1.0 APPLICATION SUMMARY

Applicant: RD Management, LLC

Request: To combine 3 blocks (Blocks 2, 3 and 4) into one single block.

RE: PRS 24-0023

Current Configuration

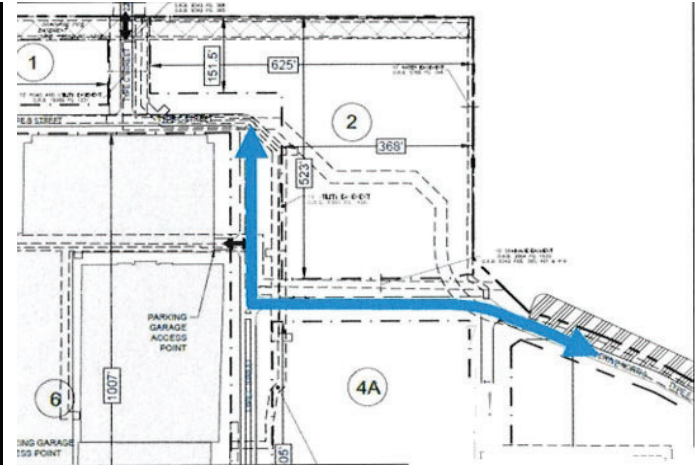
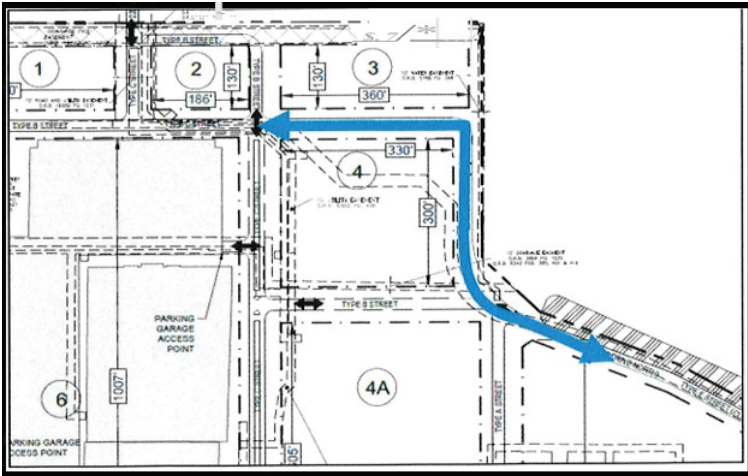
For this Minor Modification, the Applicant requests to combine Blocks 2, 3, and 4 into a new "Block 2" to develop a multi-family project. Additionally, the Applicant requests modification of Condition 5.2 to reconfigure Club Drive so that Club Drive runs along the south side of Block 4 instead of between Blocks 3 and 4:

Two portions for Type B streets are being removed on the north and east of the proposed new block. Since the new Block 2 will not have streets along the north and east, current condition 5.2 will be amended as follows: *"With the exception of Block 6, maximum block perimeters shall be 2,500 linear feet. With the exception of Block 2, blocks shall be bounded on all sides by streets. An alley may be provided between blocks to allow access to an existing parking structure or between a new building and an existing structure."*

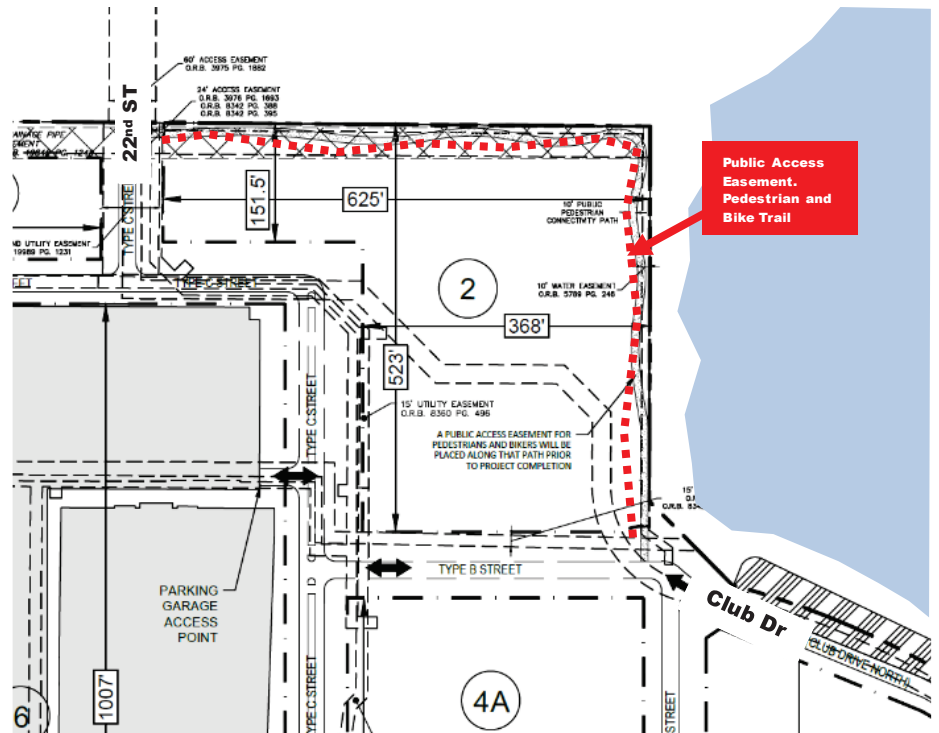
After staff evaluation of this PRS, the applicant made updates to the block design. A multiuse trail along the north and east of the New Block #2 will be provided to allow pedestrian and bike access along the NE boundary of the project. The trail will run adjacent to a pond located NE of the PD and will connect Club Drive from the southeast to 22nd St. to the northwest. Access by the public will be allowed by an access easement so that connectivity and integration contemplated by the overall project and the ICMU-35 FLU intent is maintained. The applicant proposes that the trail be a minimum of 10 feet wide. According to the applicant, and due to ongoing public safety concerns with areas inhabited by vagrants along the north and east of the proposed project,

only the easement area where the trail will be placed will be reserved at the time the project is developed. The trail will be built at a future stage when safety issues are addressed by the project operator. Development Services staff is proposing a timeline for the multiuse trail to be completed. No more than Six (6) months after certificates of occupancy have been issued for the multifamily project, the developer will be required to submit site development application for

the multiuse trail. The trail will be required to be built no later than 12 months after the issuance of certificates of occupancy. While there is no specific site design or building design for the proposed multifamily project yet, staff recommends that in order to maintain the overall design standards established by the PD, a condition will be added to require multifamily building facades facing the trail to consist of windows and/or balconies at a minimum rate of 50% of the wall area.

GENERAL DEVELOPMENT PLAN

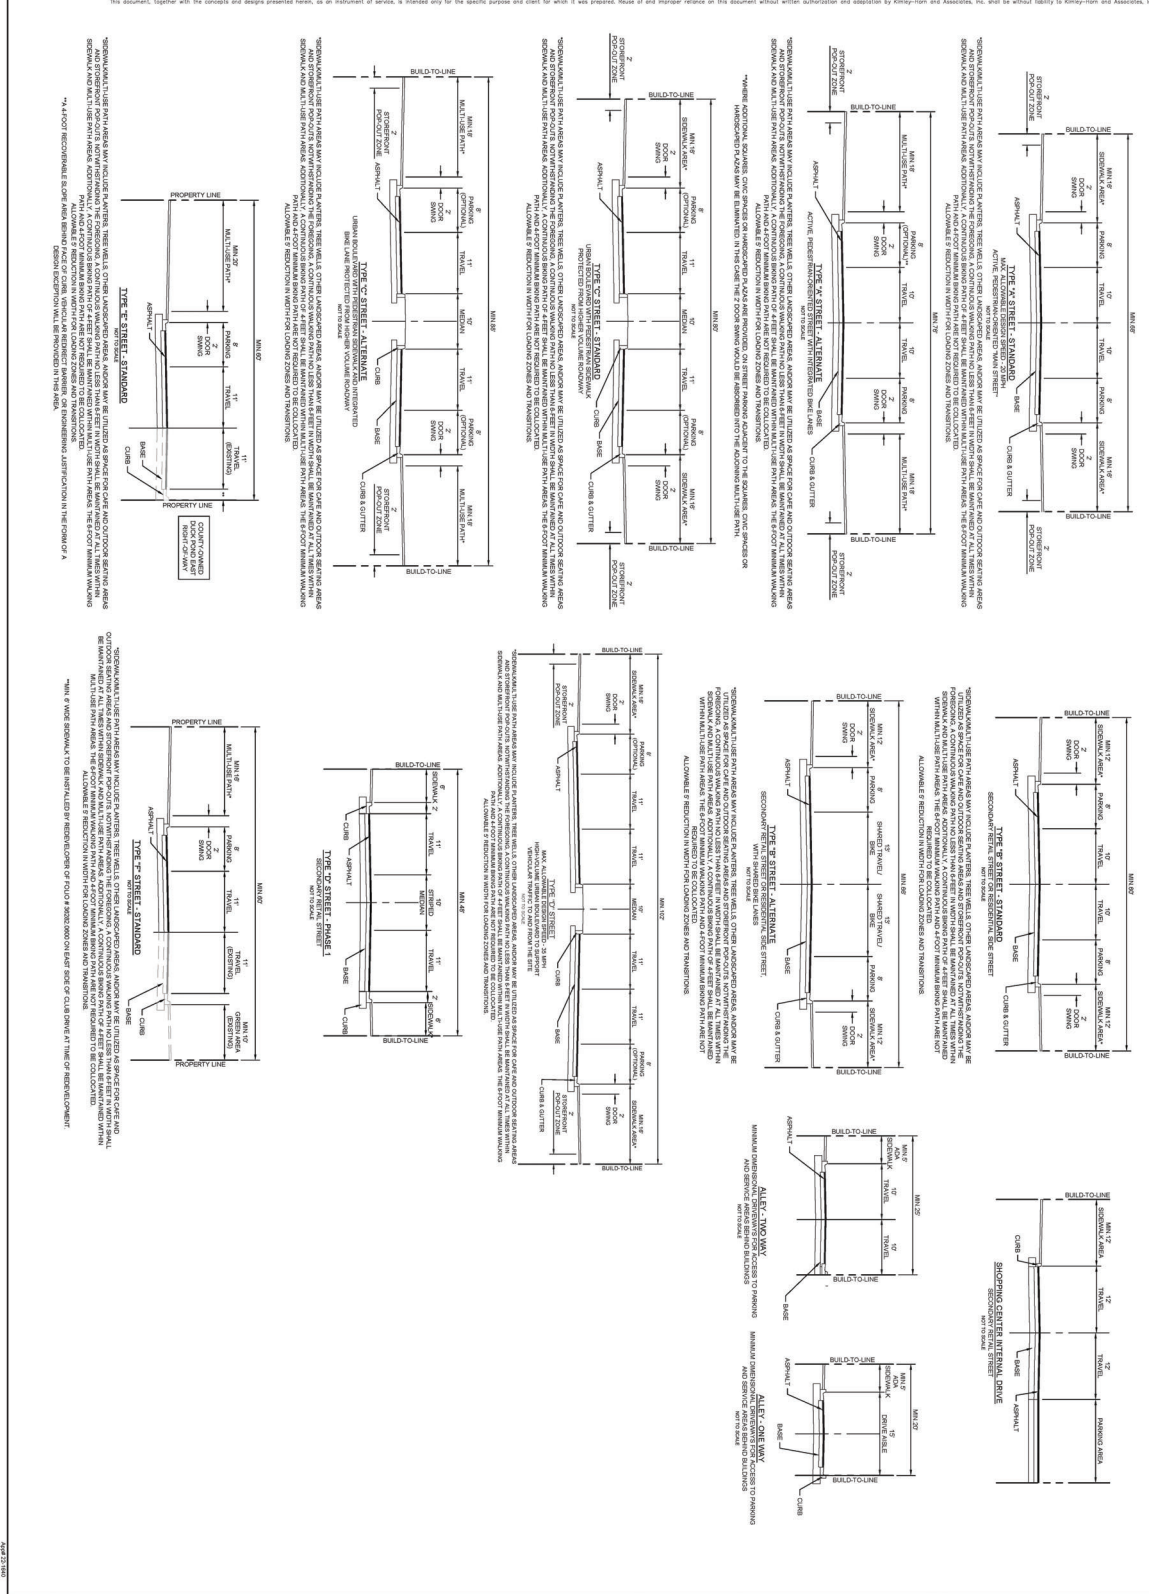
- 5.1 Location of roadways, street types and blocks shall generally conform to the layout as shown on the Sheet 1 of the PD General Site Plan. At each Preliminary Development Site Plan application for specific projects, the developer shall provide a general site plan depicting the subject site development plan within the context of the entire PD zoning district to demonstrate general conformance with the PD General Site Plan. Any deletion of a roadway, change of street type or reconfiguration of blocks that change the basic form of the blocks will require approval by the Board of County Commissioners in accordance with LDC Section 5.03.07.

- 5.2 With the exception of Block 6, maximum block perimeters shall be 2,500 linear feet. With the exception of Block 2, blocks shall be bounded on all sides by streets. An alley may be provided between blocks to allow access to an existing parking structure or between a new building and an existing structure. Additionally, the below conditions shall apply to Block 2 of the Development Plan:

- a. An access easement area a minimum of 10 feet wide, for a multiuse trail (pedestrian and bike), shall be provided along the north and east of Block #2 as shown on the General Development Site Plan. The access easement shall be recorded prior to Construction Plans approval for any project within Block #2.
